PLANNING COMMISSION STAFF REPORT

Petition No's. 410-07-25 and 490-07-44 North Port Commerce Center Planned Development and Subdivision Located Approximately at 1802 – 1880 North 2200 West.

Public Hearing Date: February 27, 2008

Planning and Zoning Division
Department of Community
Development

1 ARCHITECTURAL SITE PLAN
 ASI
 SCALE 1"=50'

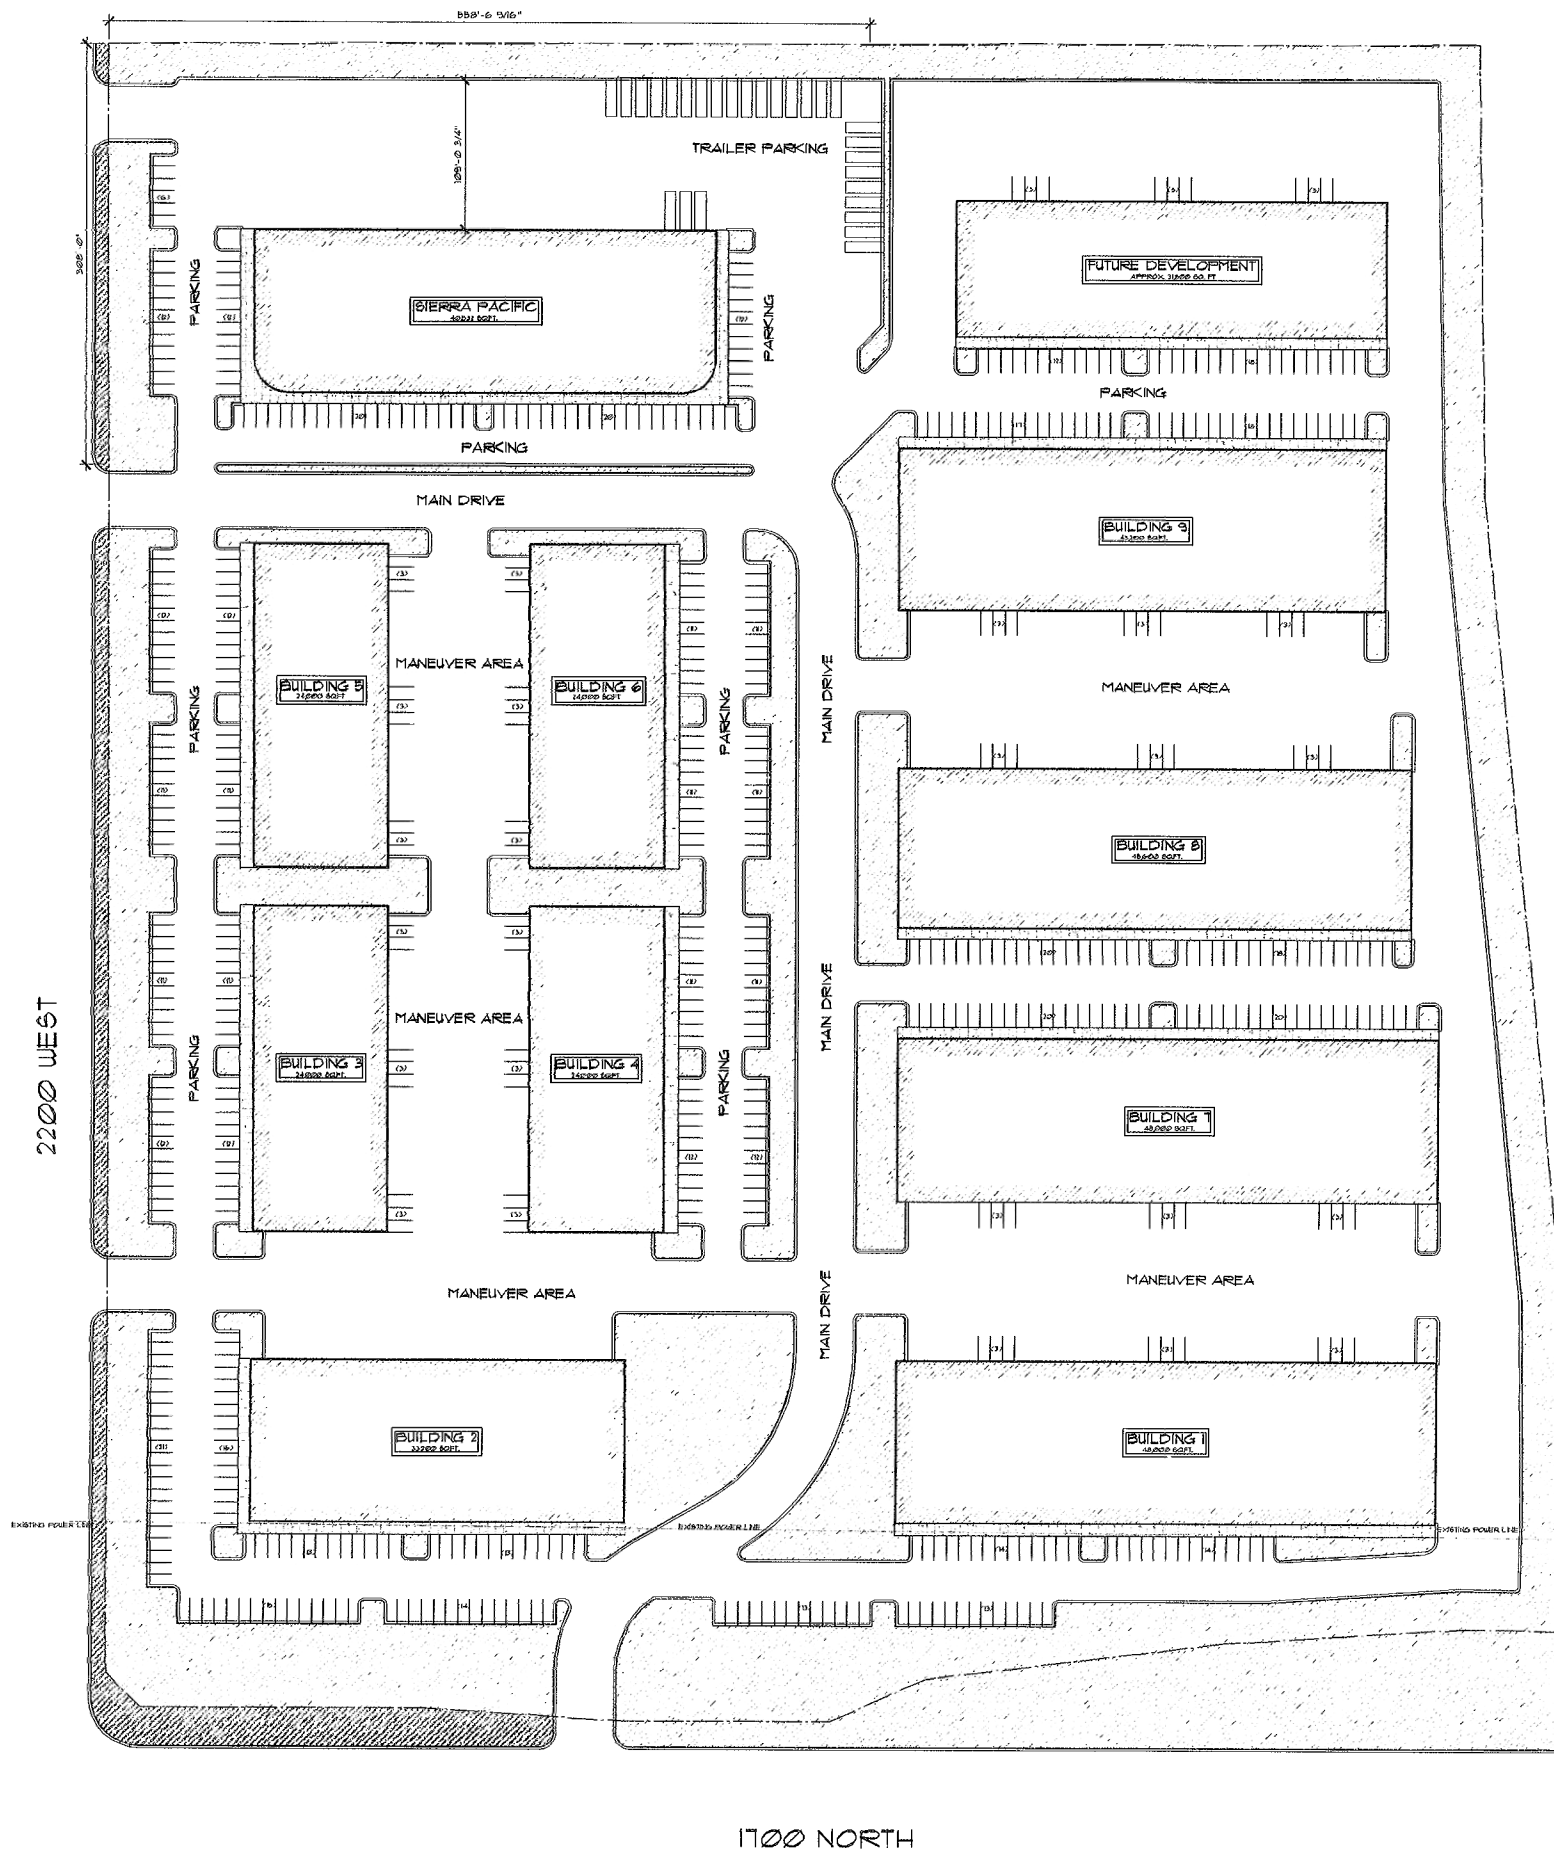
- 1) The AS1 sheet submitted for this proposal should include all of the following,
 - a) The property lines of each parcel as determined by the North Port Commerce Center Preliminary Subdivision Plat file #490-07-44 along with the dimensions and legal description of each parcel,

- g) Adequate area along the Interstate 215 frontage of Lot 3 to provide the required twenty (20) feet of freeway scenic landscaping along with any planned site detention (if the freeway scenic landscape area is to be used for site detention, adequate area should be provided such that all required trees and shrubs can be planted above the high water line),

- (viii) Dimension of street frontage and Parkway trees required/provided based on one tree per 30 ft. of lot width (plans currently show very few trees in the parkway strip where they are required to be placed).

LANDSCAPE PLAN
SCALE 1/8" = 1'-0"
HEET

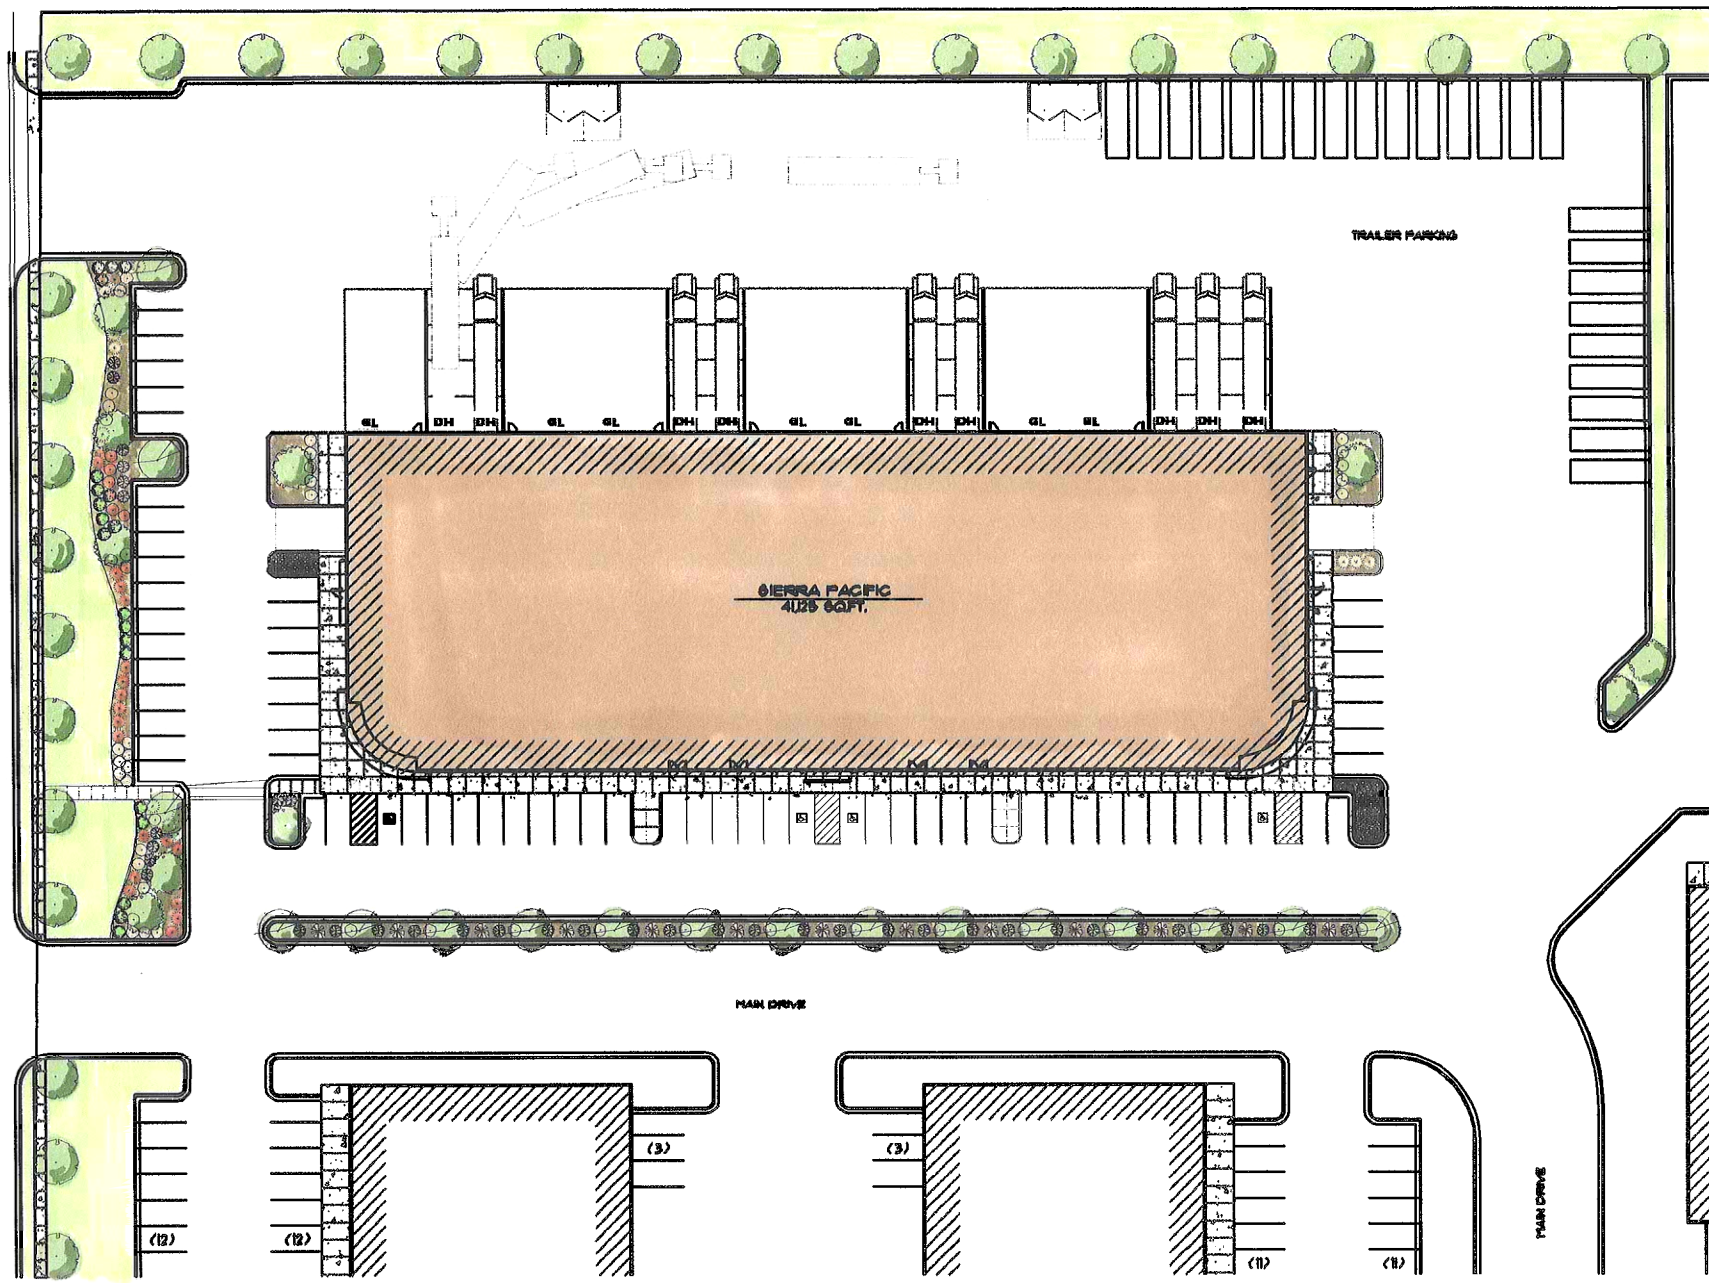
- 2) Recording of Avigation easement to be documented for permit issuance.
- 3) Landscape Plans and Plant Schedules containing the following information will help determine whether this proposal meets the minimum landscaping requirements or in what areas it may be deficient:

- a) The location, quantity, size, and name (both botanical and common) of all proposed plants for each

- lot;
- b) The type and location of all proposed ground covers including both botanical and common names of vegetative ground covers for each lot;
 - c) The location, size, and common names of all existing plants, including trees and other plants in the parkway, and indicating plants to be retained and removed for each lot;

- g) Total percentage of drought-tolerant trees and shrubs (80% minimum required).
- Note: Utah Power and Light should be contacted regarding trees planned under or near power lines.
